ADDENDUM 1 (PENDING DSA APPROVAL)

PROJECT: **Santa Ana College**
 Science Center

DATE: 8/23/2017

DSA File No.: 30-C2
DSA Applications No.: 04-115788
HGA Commission No.: 3584-001-00

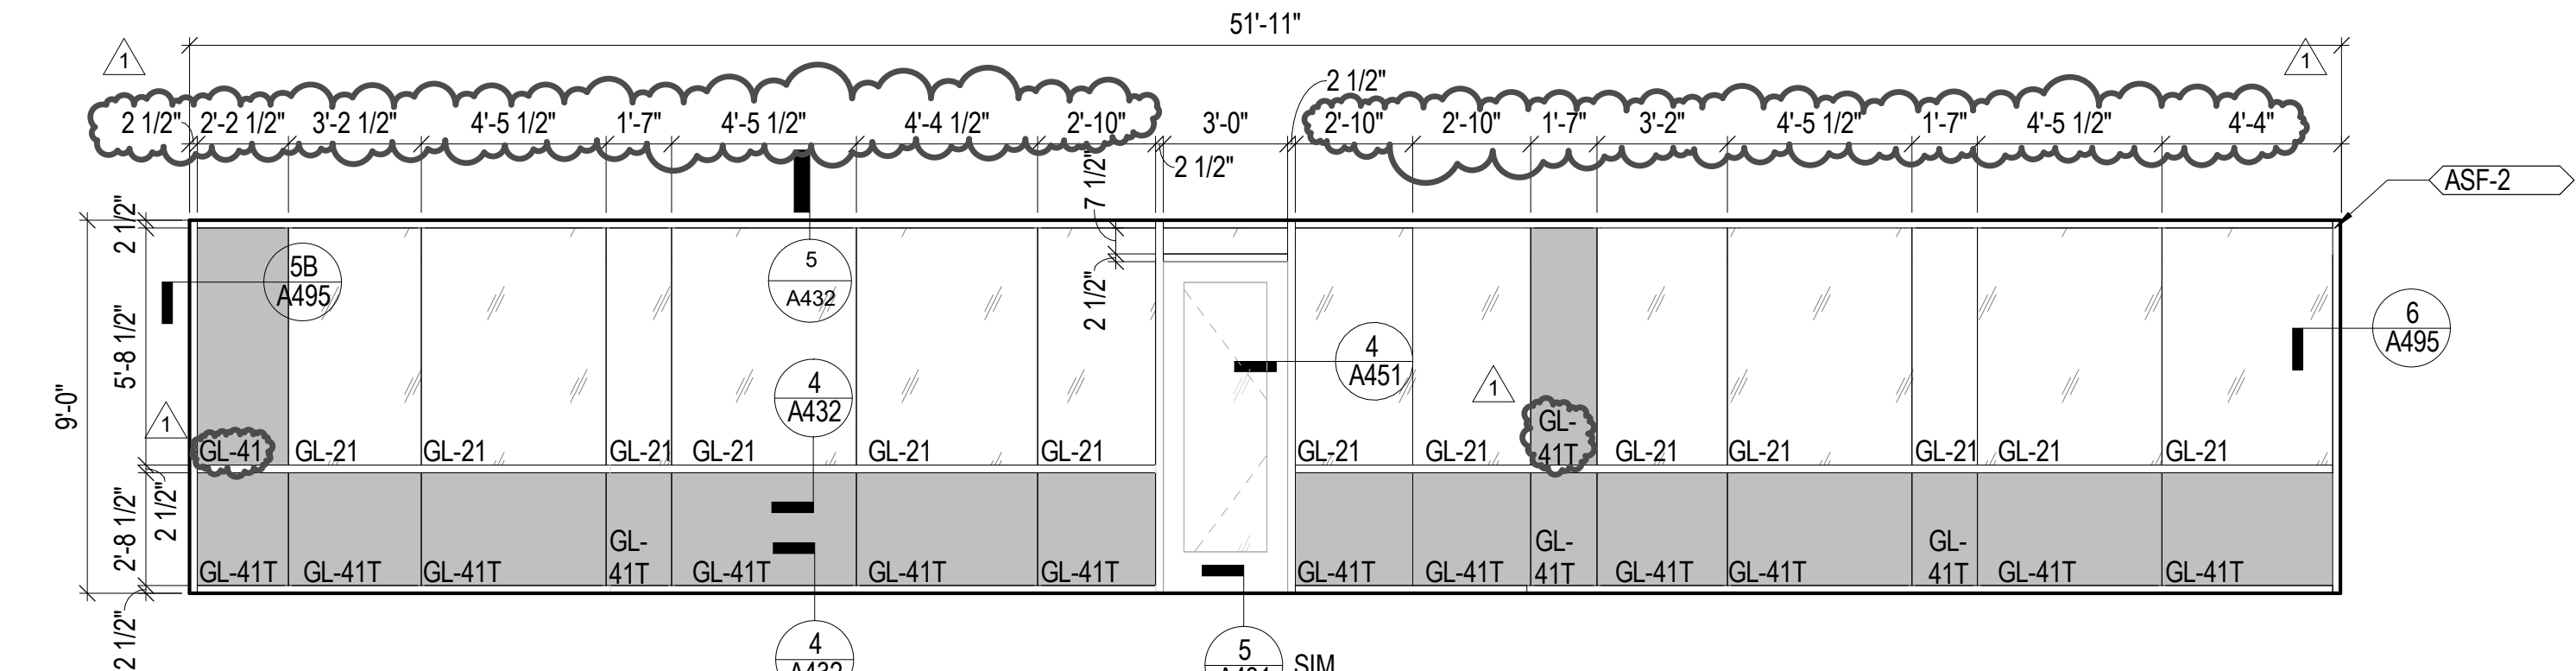
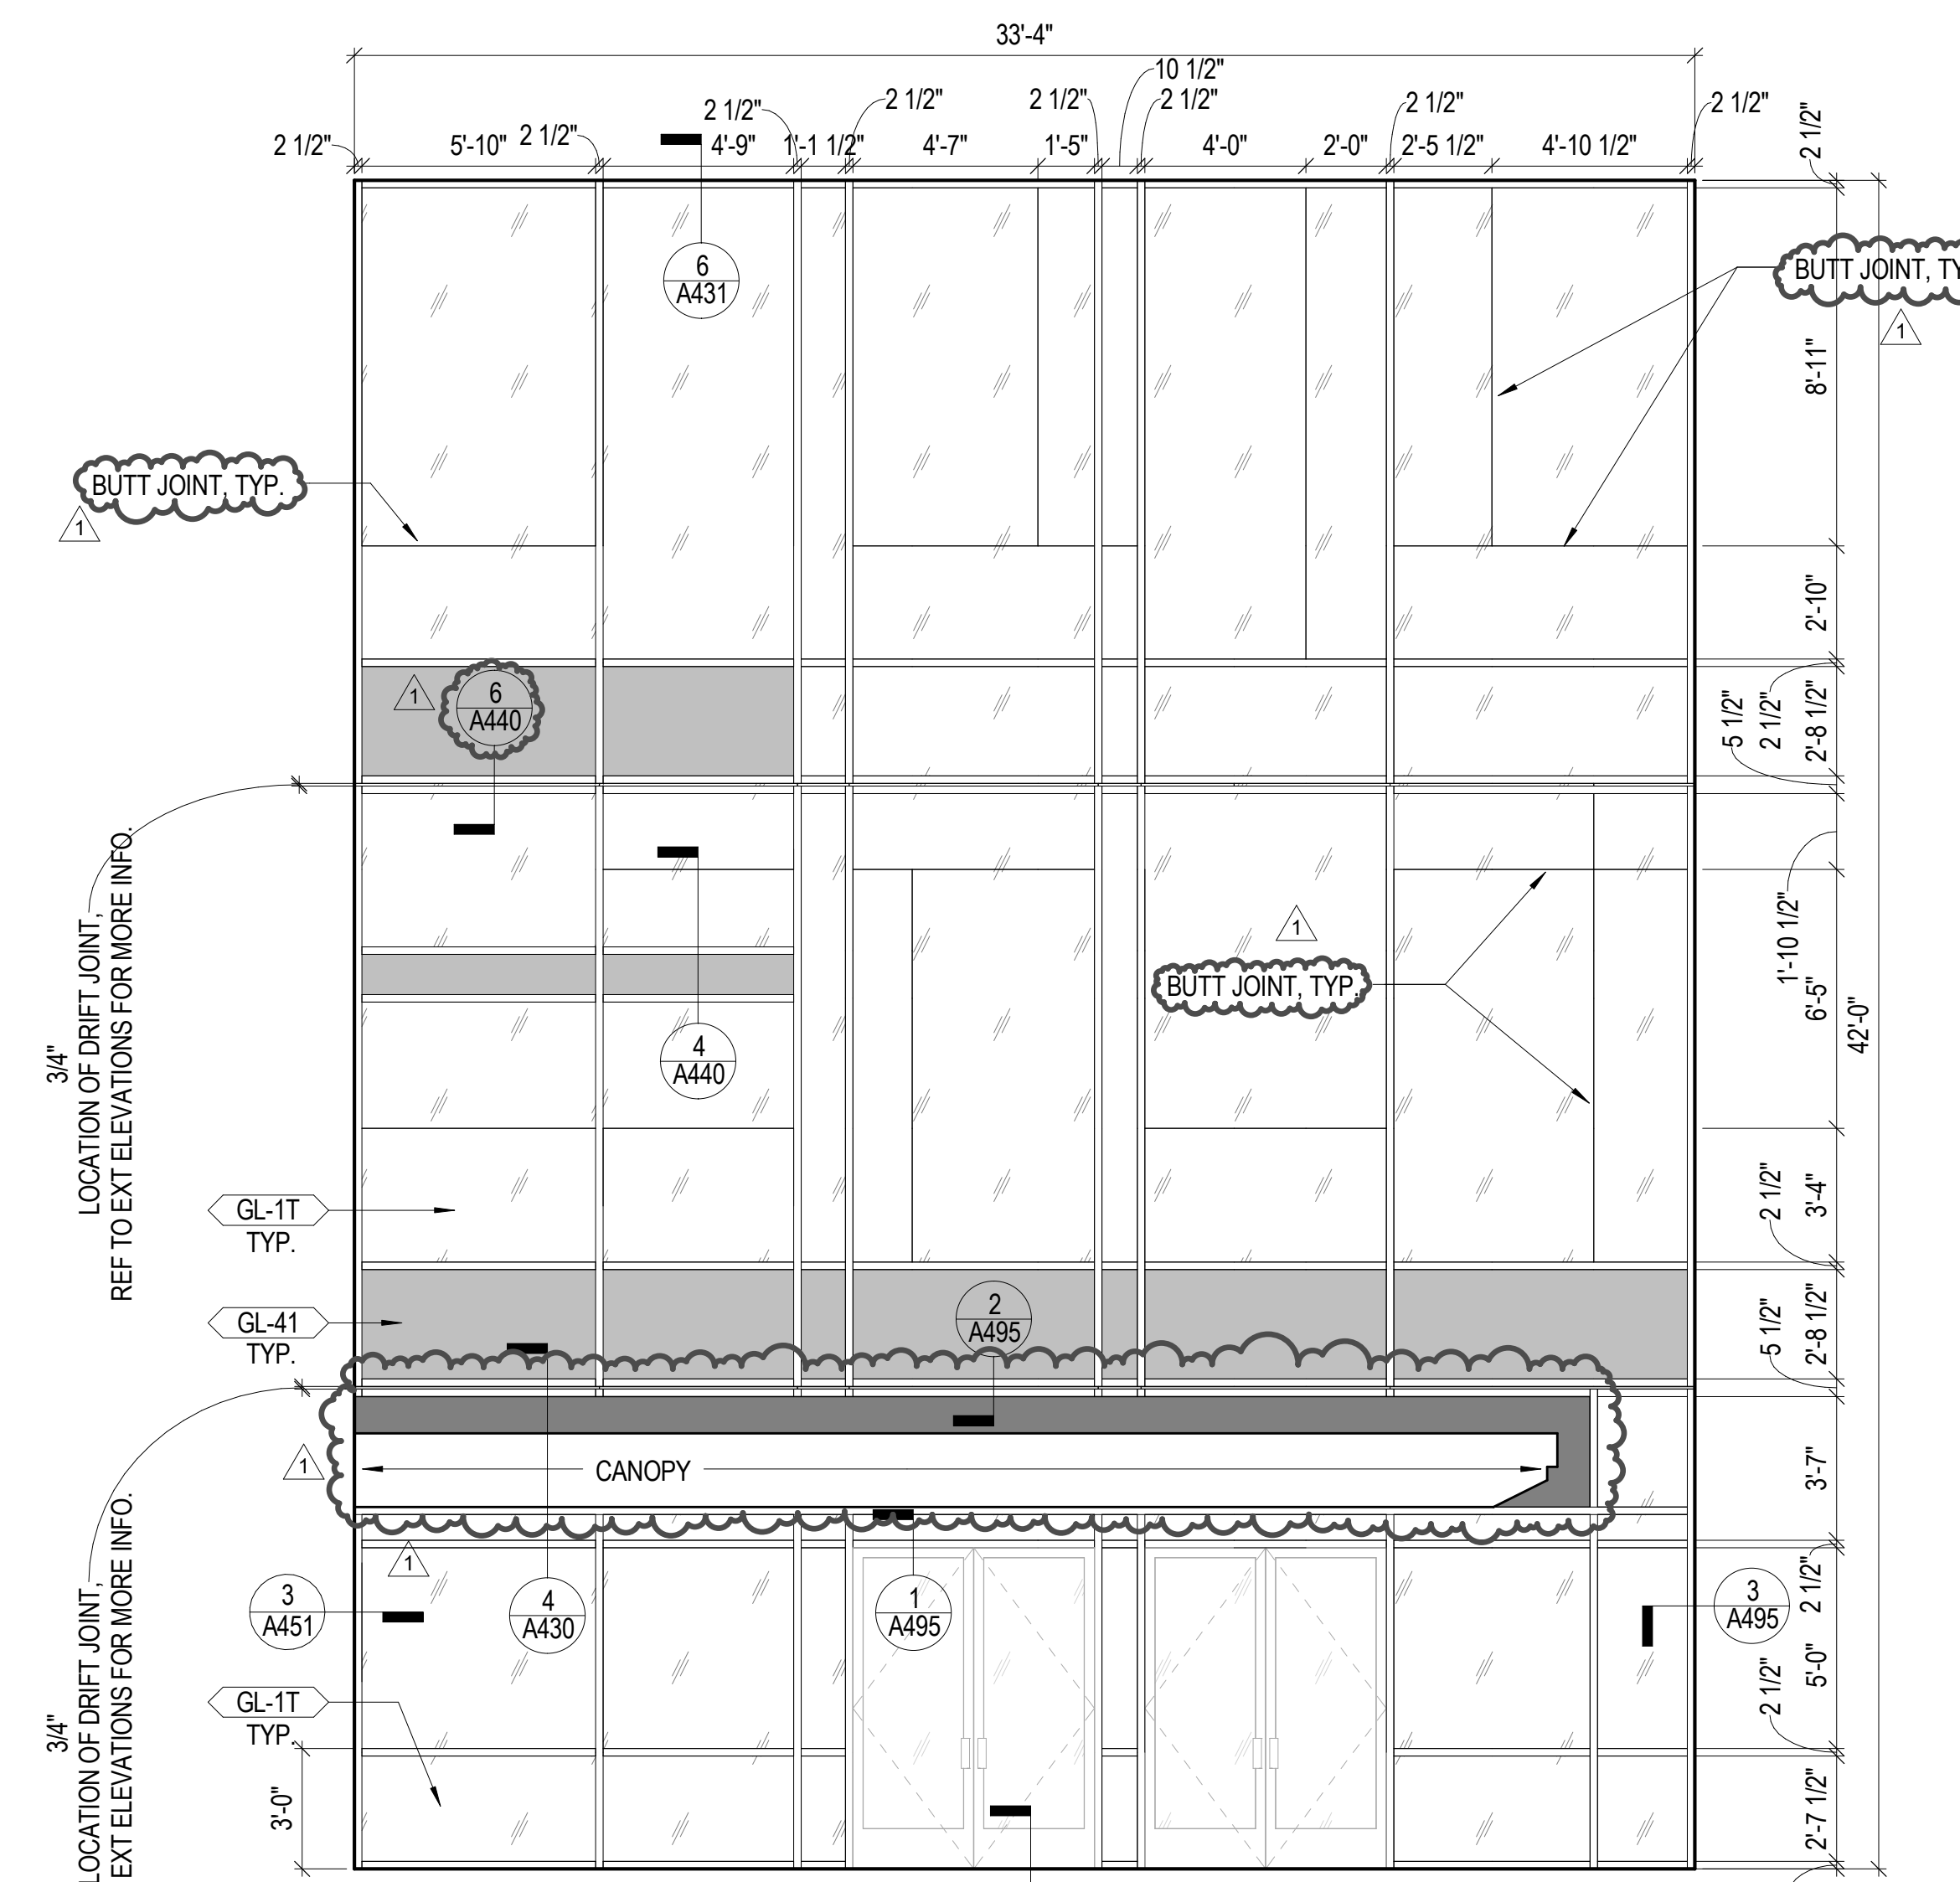
- Location of butt joints and glass type at storefront changed at Detail 4 and 5.
- Location of butt joints at curtainwall changed at Detail 1.

- Added detail reference 6/A440 at drift joint location at Detail 1, 2, 3, and 10.
- Clarified condition at canopy at Detail 1.
- Note added for all glass located on first floor and below to be laminated glass.
